# Application Ref: NP/11/239

New agricultural building for livestock housing

Llanungar Fawr, Solva, Haverfordwest, Pembrokeshire,

Location Plan 1: 2500 06.2011 SLH

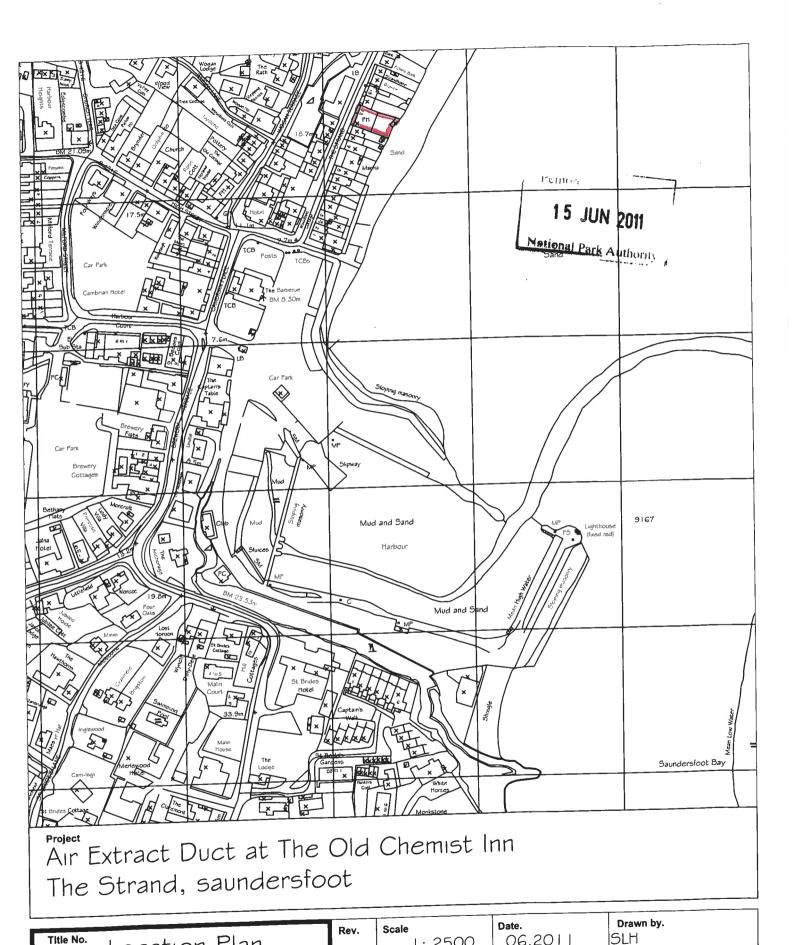
- 1. The siting of the proposed development would, by reason of its divorce of nature from the main farm complex, detract from the character and visual amenity of the area, contrary to the requirements of policies 1, 8, 15 and 30 of the Local Development Plan, Chapters 4 and 5 of Planning Policy Wales Edition 4 and the guidance set out in TAN 6 (Planning for Sustainable Rural Communities.

- 3. The siting of the proposed development is contrary to the Aims of Planning Policy Wales Edition 4 (Chapter 6), in seeking to preserve and enhance the historic environment and protect archaeological remains, and approval would be premature pending the completion of the on going, threat led, historic environment value assessment of St David's Airfield by Cadw.
